**VILLAGE OF WESTMONT
PLANNING AND ZONING COMMISSION
AGENDA ITEM**

P/Z 15-027

TITLE: Wojtek Bialy regarding the residential property located at 5809 Fairview Avenue, Downers Grove, IL 60516 for the following:

Re: Preliminary Land Development, Stormwater & BMP Review – Site Improvement Plans for 5809 Fairview Avenue Subdivision

PRELIMINARY PLAT OF 58th STREET AND FAIRVIEW SUBDIVISION
OF

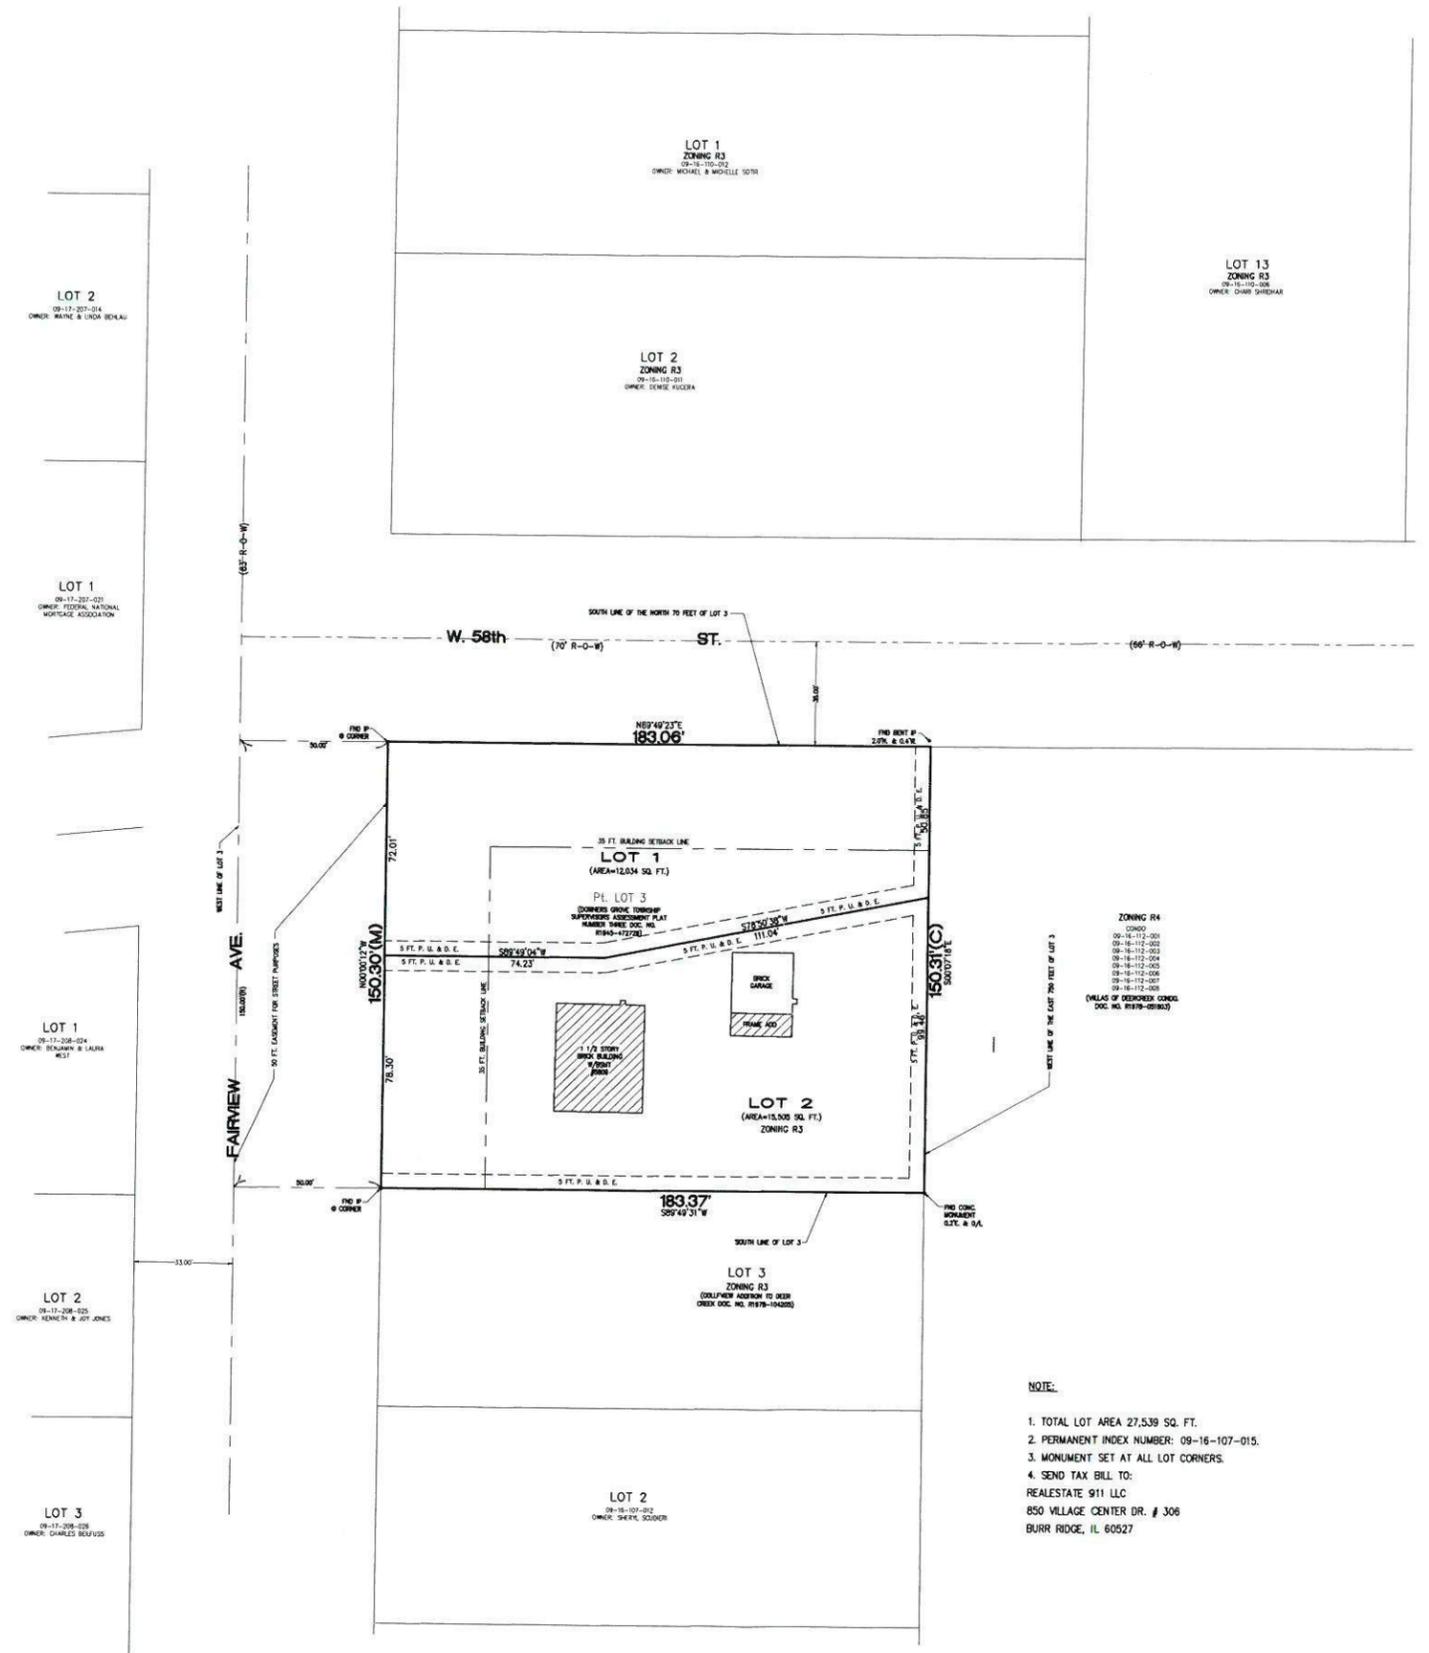
1. (SECOND REQUEST) A 10' PU & DE will need to be provided in the rear yard (east property line).
2. (SECOND REQUEST) All proposed stormwater management facilities will need to be located within a proposed Stormwater Easement. This easement, along with necessary provisions, must be provided on the Plat of Subdivision.

SITE DRAINAGE GRADING, AND UTILITY PLAN

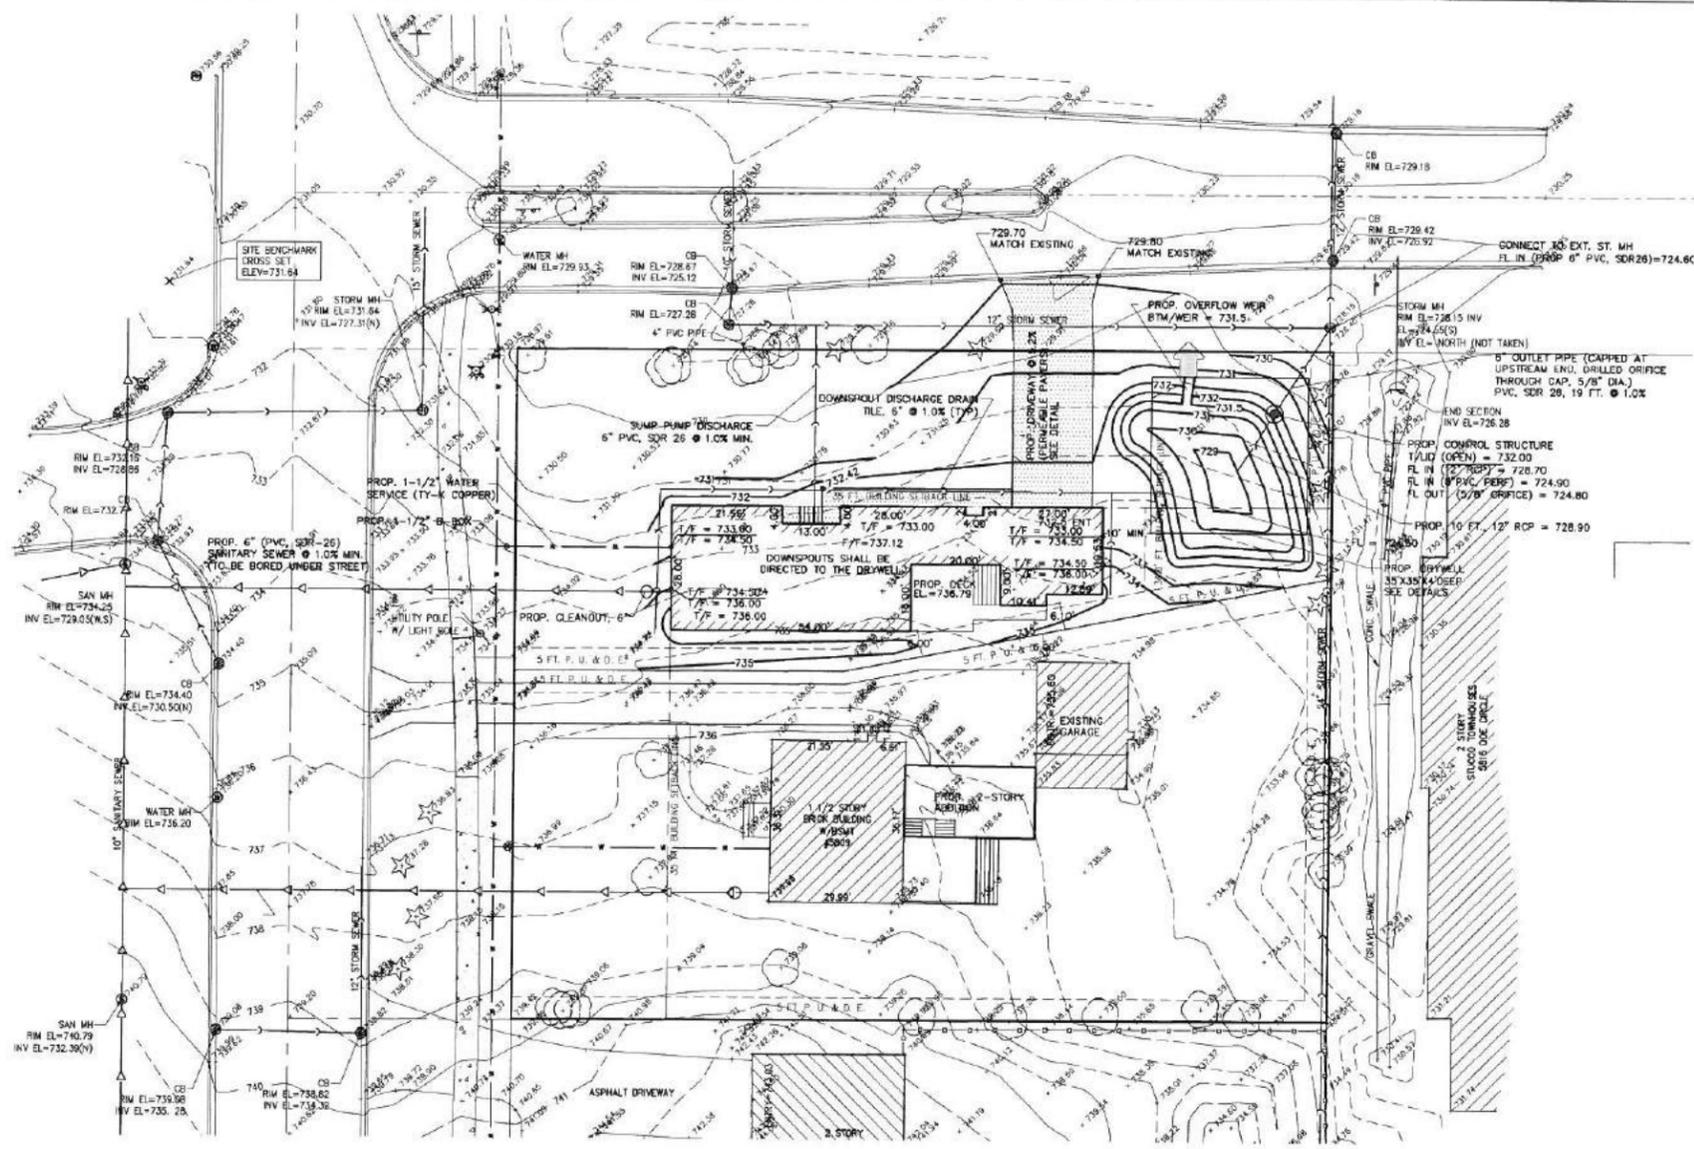
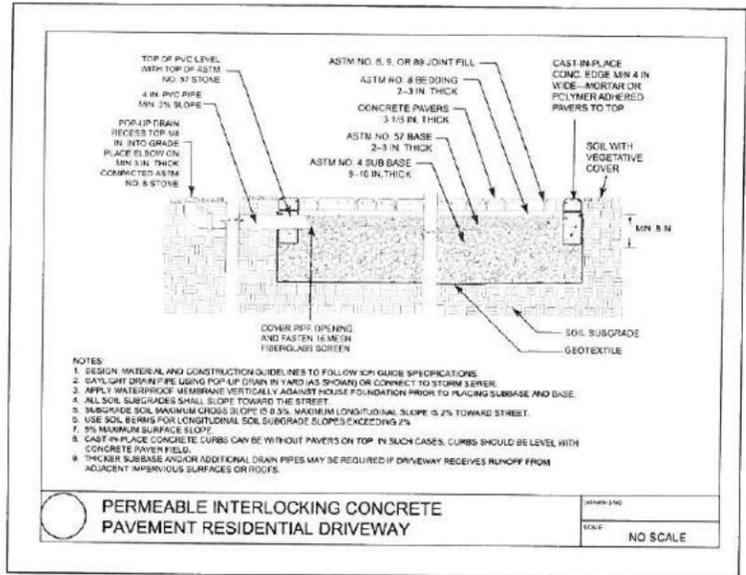
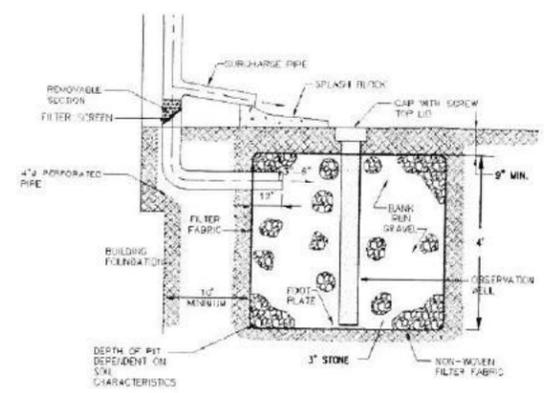
3. Relocate the construction entrance. Currently it is located on top of the location of the permeable paver driveway. Compaction of the subgrade shall be avoided.

6. Call-out the location and dimension for the launch and receiving pits on the final plans.
7. The sump pump shall tie into the adjacent system at a structure. Provide crossing elevations with the downspout discharge line.

8. Provide orifice sizing calculations for the proposed 5/8-inch orifice.
9. Provide sizing calculations and detail for the emergency overflow weir.
10. Provide drawdown calculations; VCBMP measures shall drawdown between 48 and 96 hours.

14. **The drywell must have one foot of cover. Provide the bottom of drywell elevation. It appears that the bottom of the drywell will be approximately 8-feet below the surface. The infiltration characteristics and the seasonal high**

ground water table elevation will be of concern. Additional subsurface investigation in the form of soil borings will be required.
